# PARTS & SERVICE NEWS

REF NO. AA00020

SUBJECT:	Introduction Of Improved Elbow (562-13-46911) For Torque Converter Oil Pressure Sensor on Rear Dump Trucks
PURPOSE:	To introduce an improved oil pressure sensor mounting elbow
APPLICATION:	530M Rear Dump Truck All Transmission Assemblies Prior to s/n 5046 (Part# 562-14-41002) All Torque Convertor Assemblies Prior to s/n 1452 (Part# 562-13 21002)
FAILURE CODE:	131738

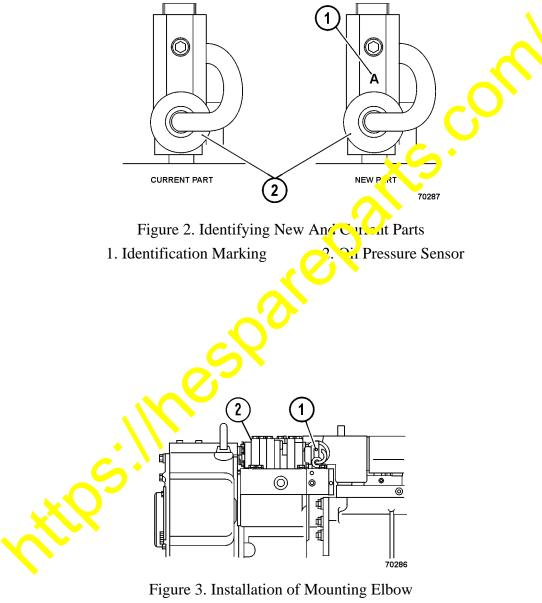
The mounting elbow (1, Figure 1) for the torque converter oil pressure consor being used on the 530M may break from its bolt joint section when excessive vibrations are applied. The material of the mounting elbow has been changed to increase the durability to prevent breaking.

Old Part Number	New Part Number	Qty.		Description
562-13-46910	562-13-46911	2	EI BOW

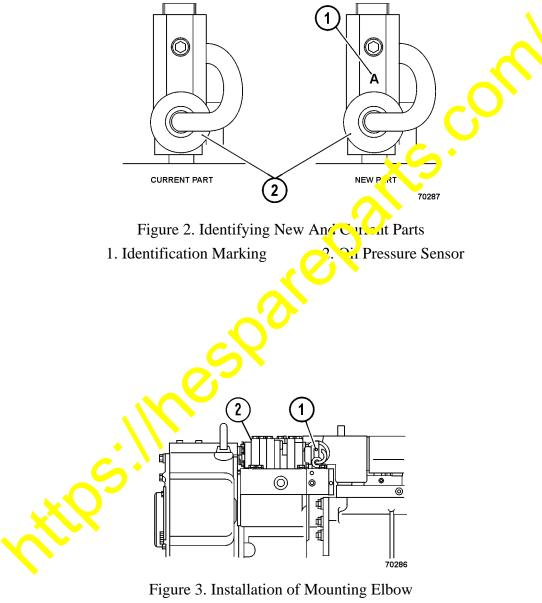
The mounting elbow (1, Figure 1) for the torque converter oil pressure consor being used on the 530M may break from its bolt joint section when excessive vibrations are applied. The material of the mounting elbow has been changed to increase the durability to prevent breaking.

Old Part Number	New Part Number	Qty.		Description
562-13-46910	562-13-46911	2	EI BOW

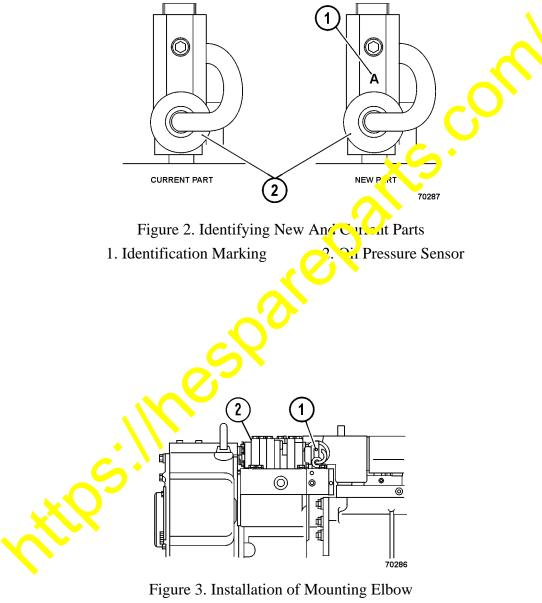
The mounting elbow (1, Figure 1) for the torque converter oil pressure consor being used on the 530M may break from its bolt joint section when excessive vibrations are applied. The material of the mounting elbow has been changed to increase the durability to prevent breaking.

Old Part Number	New Part Number	Qty.		Description
562-13-46910	562-13-46911	2	EI BOW

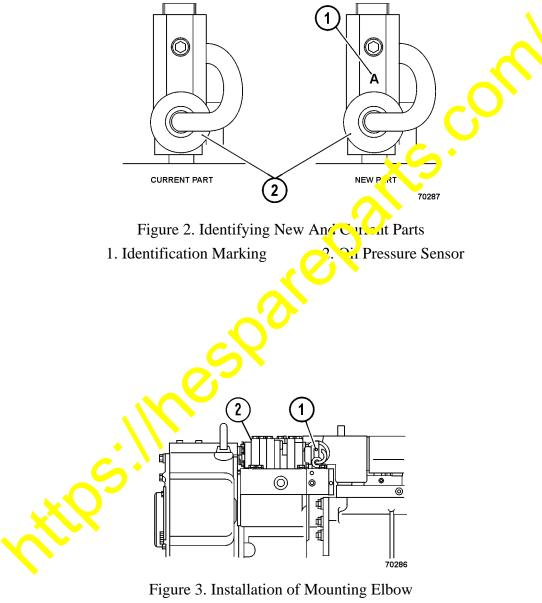
The mounting elbow (1, Figure 1) for the torque converter oil pressure consor being used on the 530M may break from its bolt joint section when excessive vibrations are applied. The material of the mounting elbow has been changed to increase the durability to prevent breaking.

Old Part Number	New Part Number	Qty.		Description
562-13-46910	562-13-46911	2	EI BOW
